Manual Supplement

Manual Title:	7526A Getting Started	Supplement Issue:	2
Part Number:	4218030	Issue Date:	8/12
Print Date:	July 2012	Page Count:	1
Revision/Date:

Change #2

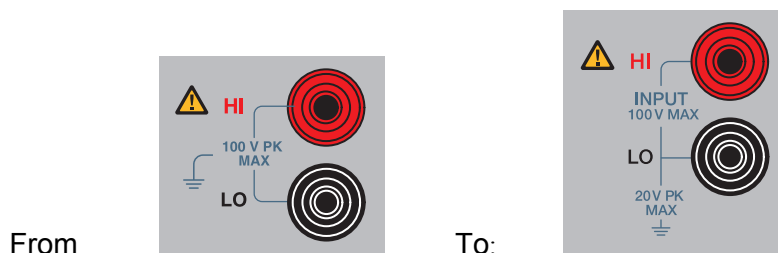
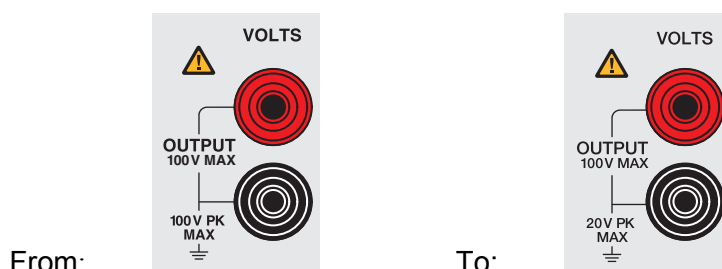
Throughout the manual, change all **Front Panel** figures:
